PRODUCT/PROCESS CHANGE NOTICE (PCN)

ATTACHMENT I - PCN # : A1911-01

Detail Of Change:

2D Barcode Information

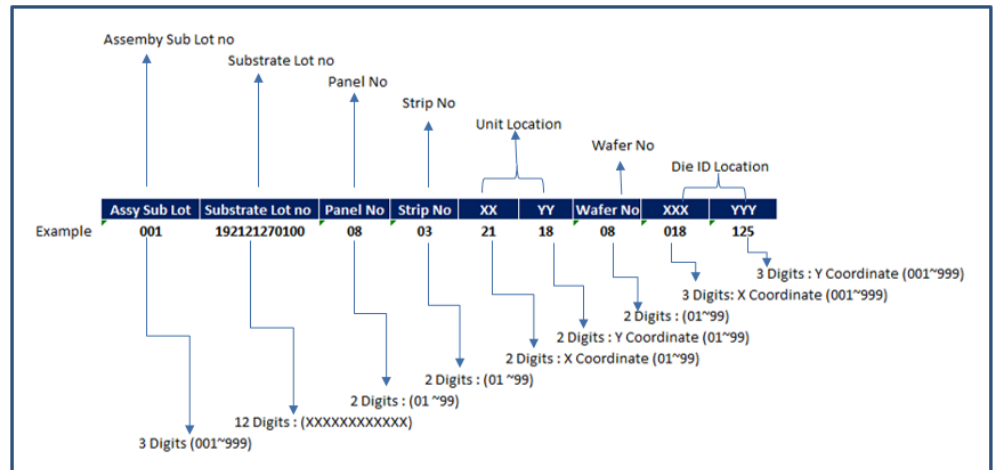
This notification is to advise our customers that IDT is adding 2D barcode on the product marking to improve traceability. The 2D barcode contains wafer and substrate information.

RCD: 13.5 x 8.0 mm

DB: 7.5 x 3.0 mm

DDR4 RCD Marking Format and Dimension

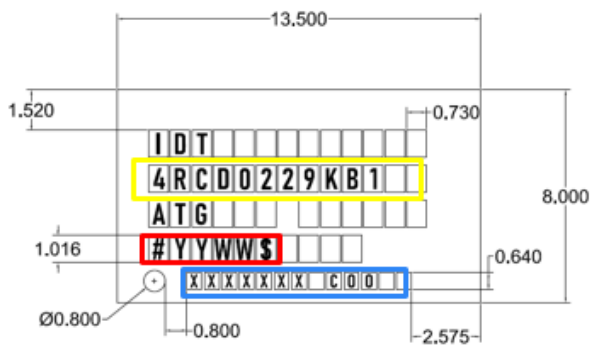
- Fixed Substrate level 2D ID Content
 - 17 digit max
 - Lot no (12) + PP + SS
- Combine Sublot + Substrate 2D ID info + Unit code + wafer and die ID and mark into IDT Unit
 - Total 31 digits
 - Assembly Sublot (3)
 - substrate Lot no (12)
 - Panel No PP(2)
 - Strip No SS(2)
 - Unit Location , XXY(4)
 - Wafer ID WW(2)
 - Die Location XXXYYY (6)

DDR4 DB Marking Format and Dimension

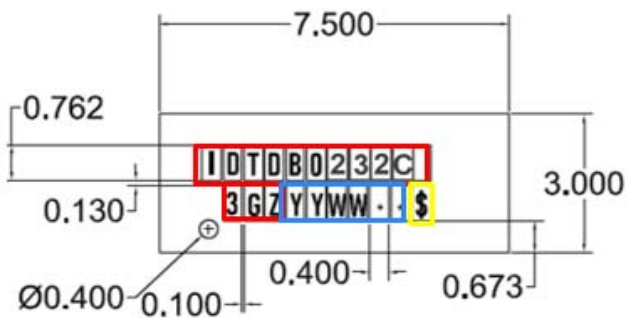
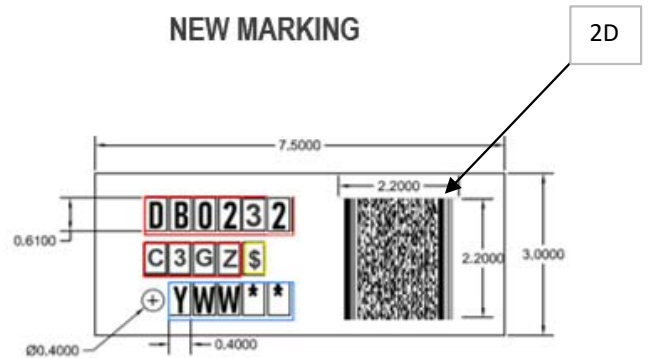
- Fixed Substrate level 2D ID Content
 - 17 digit max
 - Lot no (12) + PP + SS
- Combine Sublot + Substrate 2D ID info + Unit code + wafer and die ID and mark into IDT Unit
 - Total 31 digits
 - Assembly Sublot (3)
 - substrate Lot no (12)
 - Panel No PP(2)
 - Strip No SS(2)
 - Unit Location, XXYY(4)
 - Wafer ID WW(2)
 - Die Location XXXYYY (6)
